MFN 06-360

CD – Revision 2 to DCD Tier 2 –

**Chapter 8 (26A6642AX, Rev. 2)
& Change List**

**26A6642AX
Revision 2
September 2006**

Figure 8.1-1. Electrical Power Distribution System - One Line Diagram
Sh 1 of 3

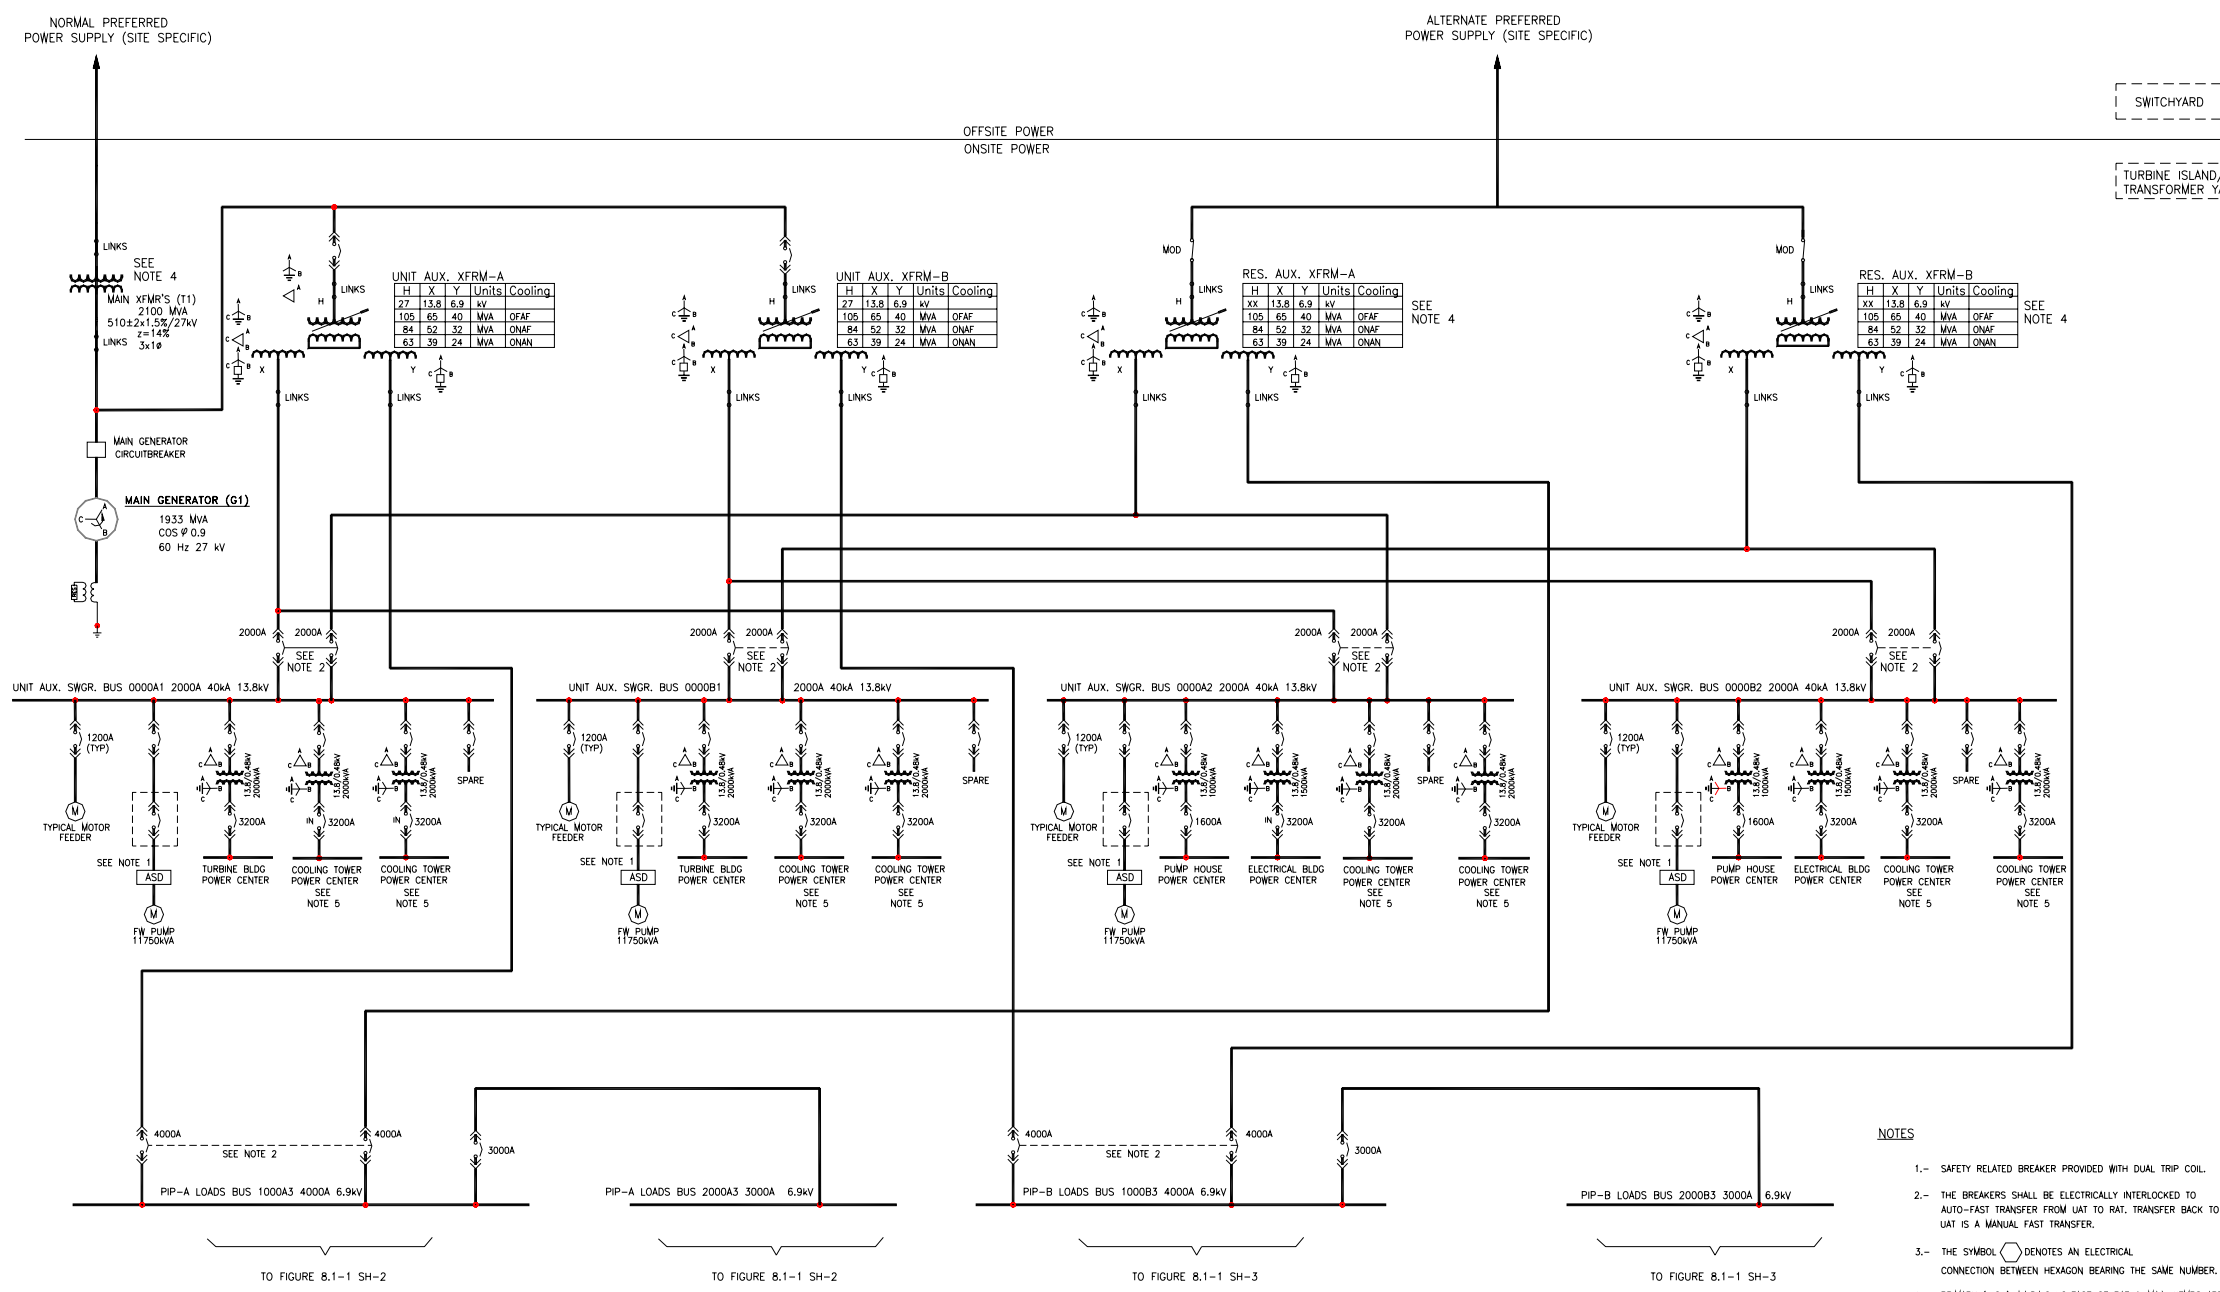
45	Figure 8.1-1, Sheet 1	Revise the dotted line to go through the drawing above the main transformers, UAT and RAT's and show "OFF SITE POWER" above the line and "ON SITE POWER" below the line. Clarification to show ESBWR standard design as "ON SITE" and OFF SITE to be site specific in design.
46	Figure 8.1-1, Sheets 2 and 3.	Editorial for PIP Bus label and show interlocks at Diesel generator feeder breaker to Normal and Alternate feeder breakers.
47	Figure 8.1-2, Sheets 1 and 2.	Redrawn for clarity.
48	Figure 8.1-3	Added second batteries, chargers and 250VDC power centers to divisions 3 and 4 to provide 72 hours of 120 VAC power with deletion of all 480 VAC safety-related loads.
49	Figure 8.1-4	Added second UPS (rectifiers, diodes, inverters, transformers, static and maintenance transfer switches and 120VAC load buses to divisions 3 and 4 to equalize load capacity and ensure 72 hour ampacity for all four divisions of safety-related power.

Figure 8.1-5. Uninterruptible AC Power Supply (Non-Class 1E) - One Line Diagram
Sh 2 of 2

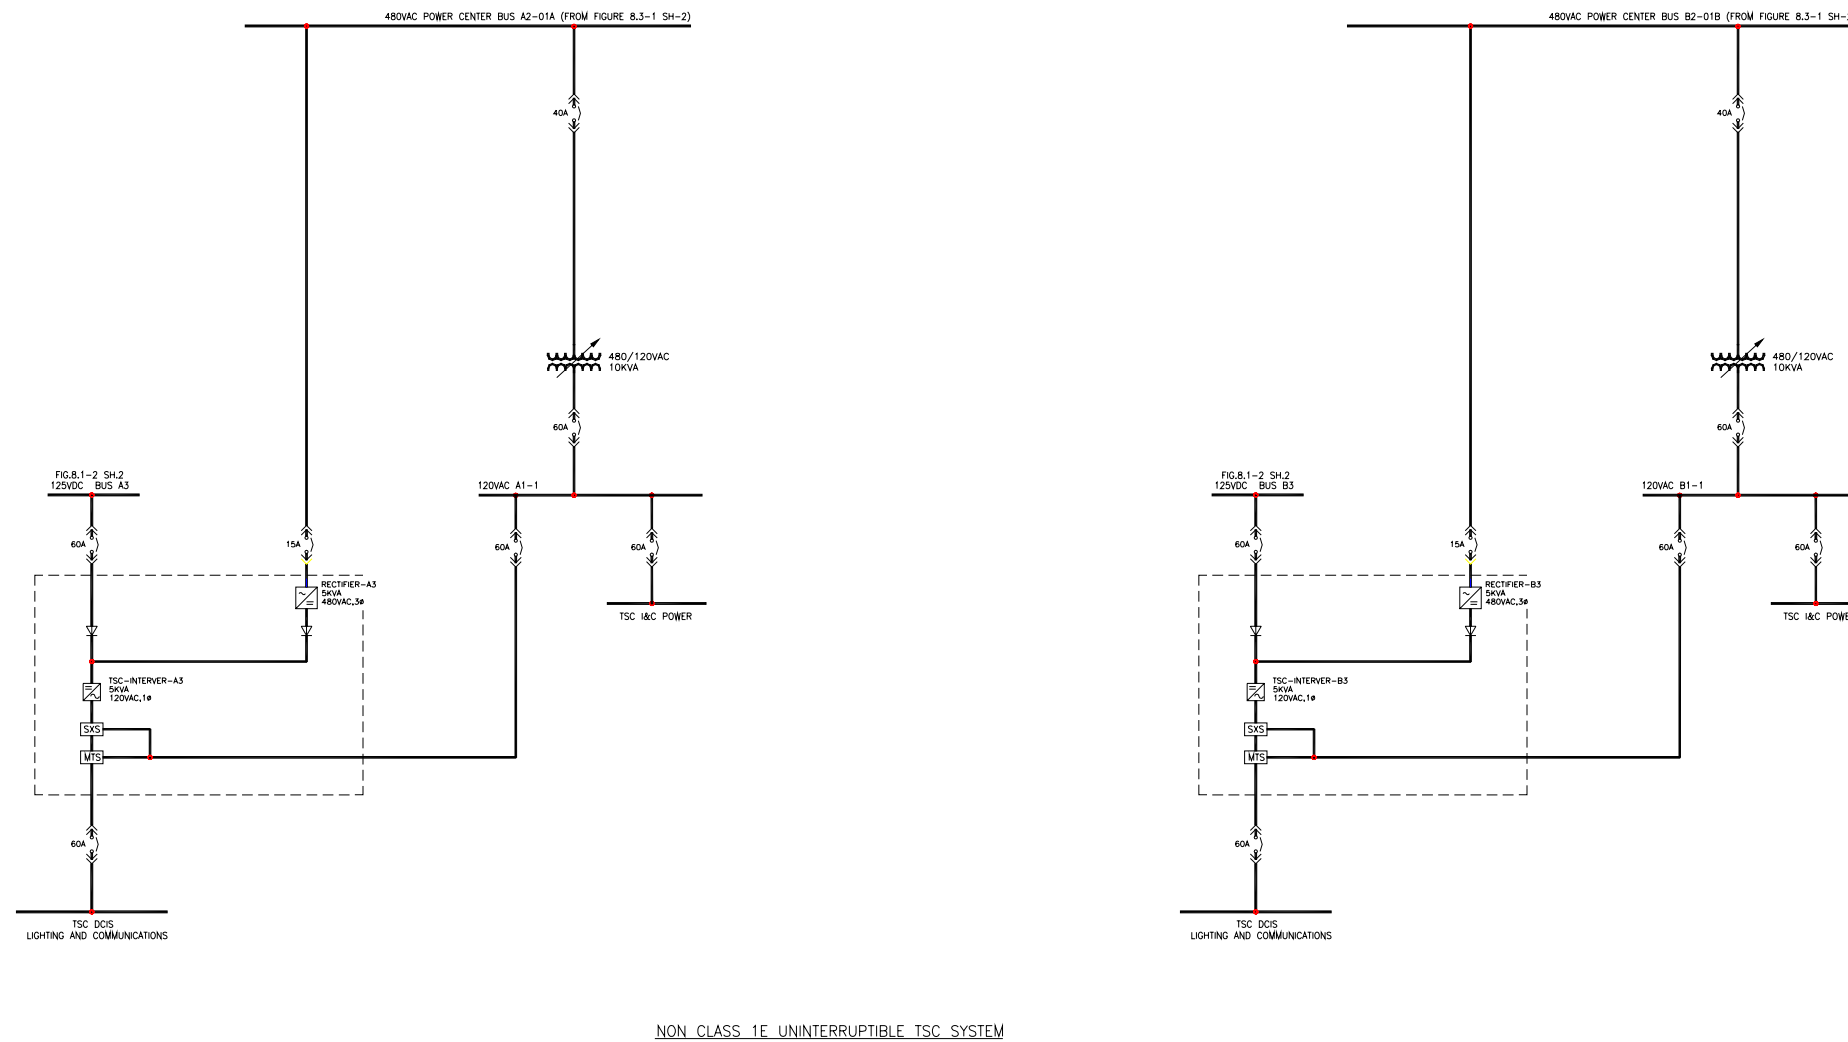
50	Figure 8.1-5, sheet 2.	Editorial correction to show correct power center supplying UPS rectifiers A3 and B3.
51	Figure 8.1-6, sheet 1 of 2.	Deleted this figure and the 32 breakers, four transformers, and associated buses that supplied diesel derived 120VAC power to the Class 1E safety-related I & C E-DCIS loads to be used as a second source of power for self-check. Power

Figure 8.1-6. Instrumentation and Control Power Supply System - One Line Diagram

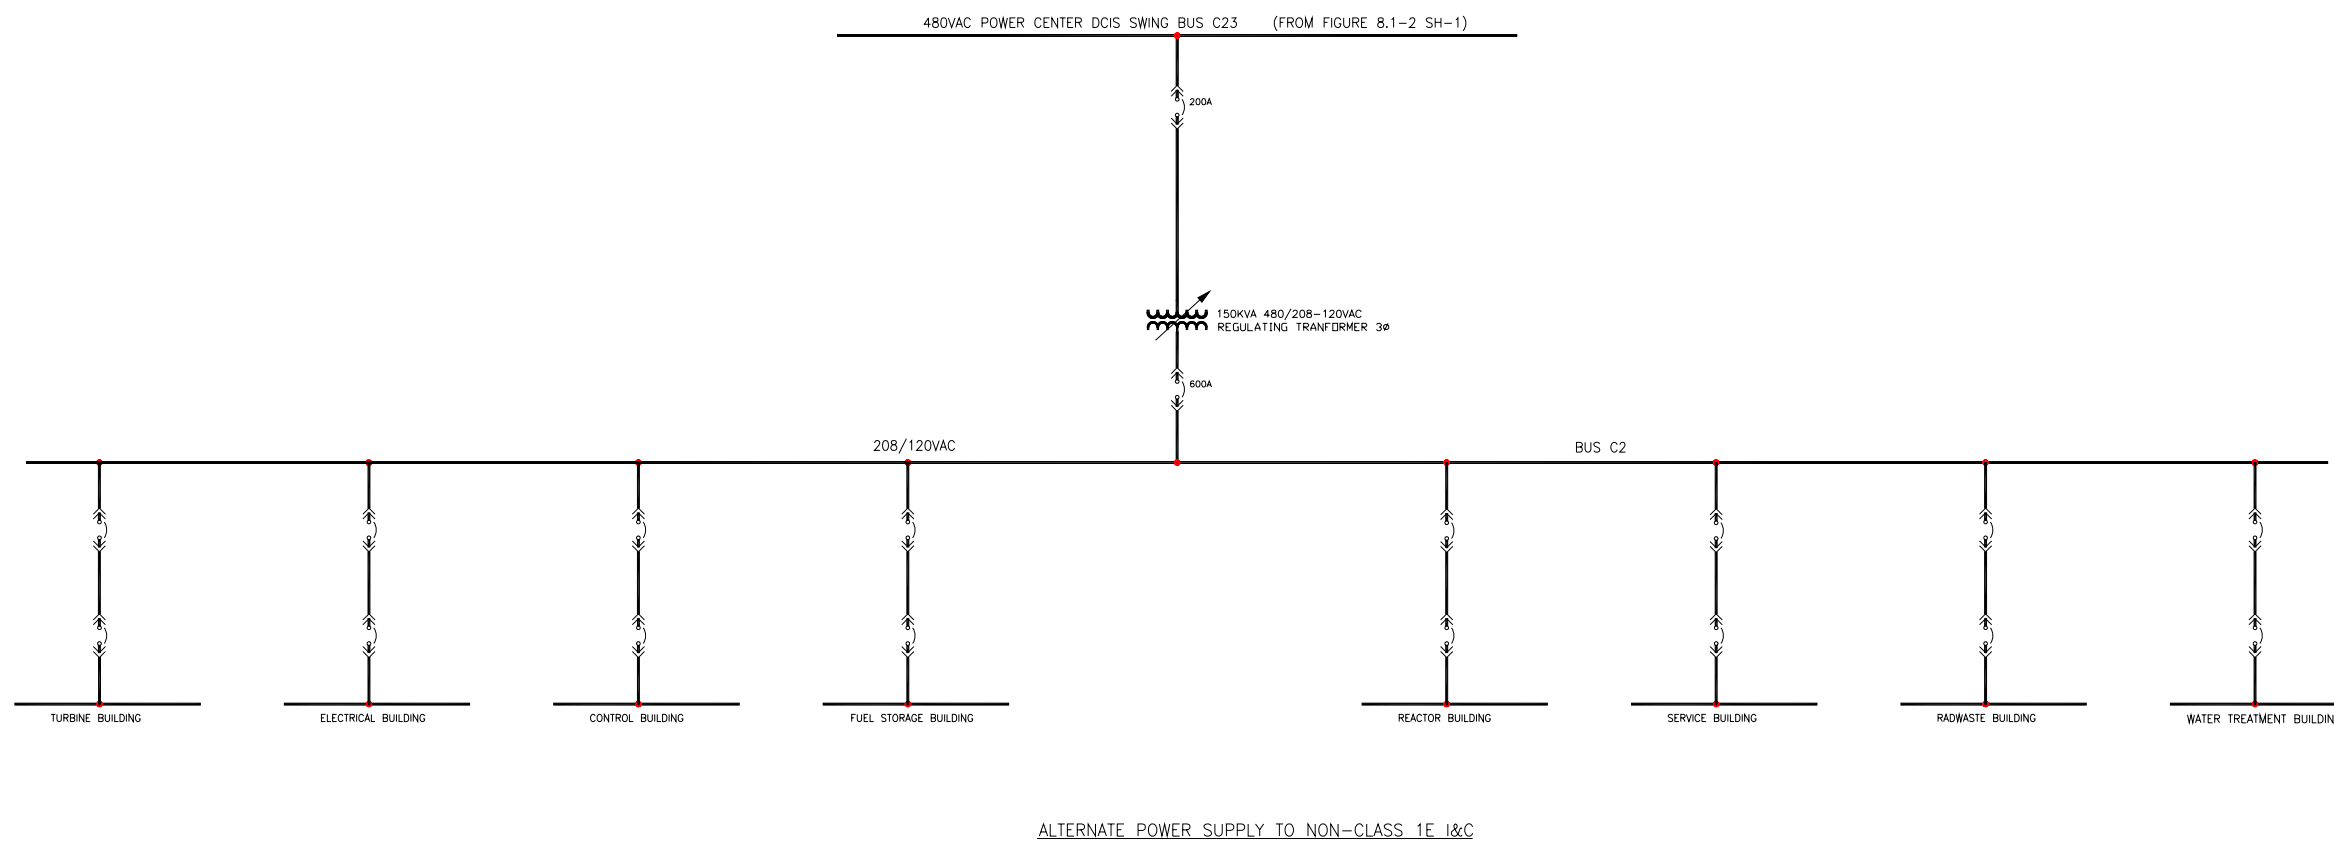
replaced with second battery of each division to ensure 72 hours of DC power without AC source required.
52	Figure 8.1-6, sheet 2 of 2.	Revised sheet number to sheet 1 of 1.
